Subject: FW: LUA 22.3166 Gods Window, Skywalk
Attachments: LUA 22.3166
Dft.BAR_NewSkywalkTourismDesign_GodsWindow_Houtbosch.503.KT_Lisbon.531.K
T_ThabaCheu_Zutari.pdf

SUBJECT: THE MTPA COMMENTS REGARDING THE DRAFT BASIC ASSESSMENT REPORT FOR THE ENVIRONMENTAL AUTHORISATION PROCESS FOR THE PROPOSED NEW DESIGN SKYWALK TOURISM FACILITY AT GOD'S WINDOW ON THE FARMS DE HOUTBOSCH 503 KT AND PORTION 2 OF THE FARM LISBON 531 KT IN THE THABA CHWEU LM, MPUMALANGA PROVINCE. Ref: DFFE 14/12/16/3/3/88/AM3.

Figure 1: MBSP Terrestrial biodiversity assessment of the Skywalk development site.

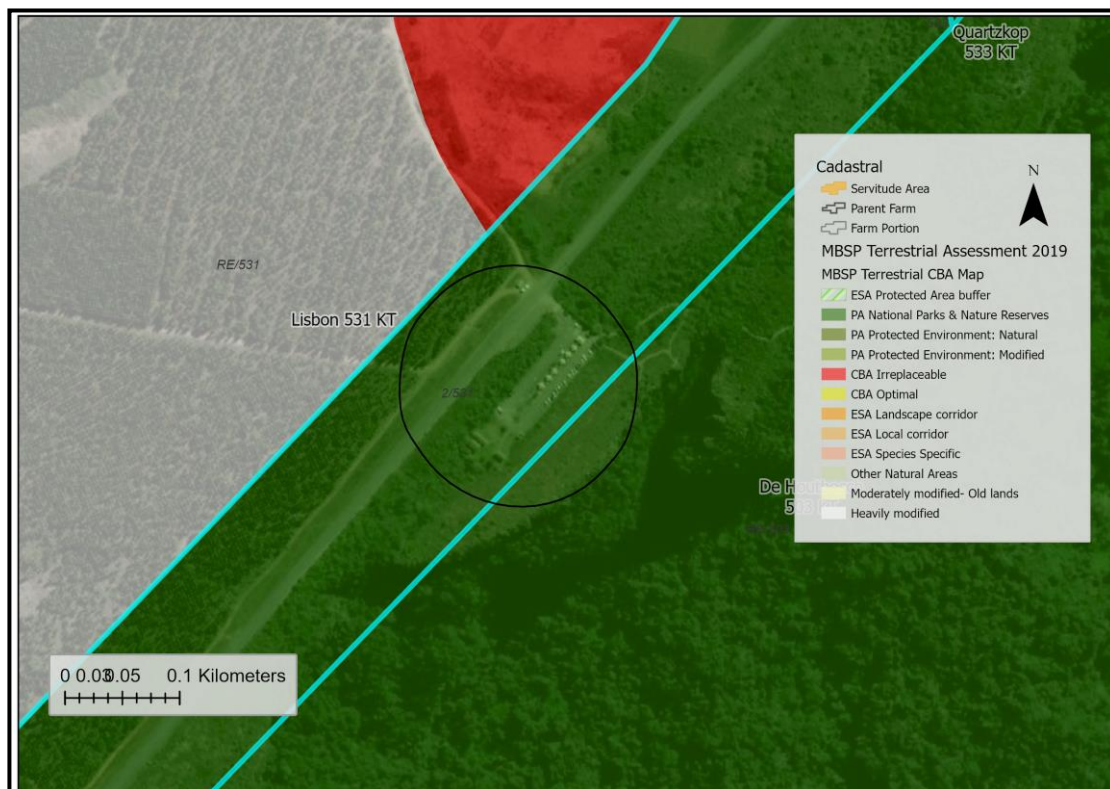
- **An important management objective should be to remove the block of exotic plantation across the street. The section within the borders of the Protected Area, refer to MBSP terrestrial map figure 1 attached. This area can then be used for construction purposes or extra parking in the future. Needs to be negotiated with the forest company as well.**

3. The focus area of the proposed tourism facility within the protected area is indicated by a circle in figure 1. The plantation on the top left within the PA borders are not needed. The indigenous forest on the top right does not pose the same threat as an exotic tree plantation
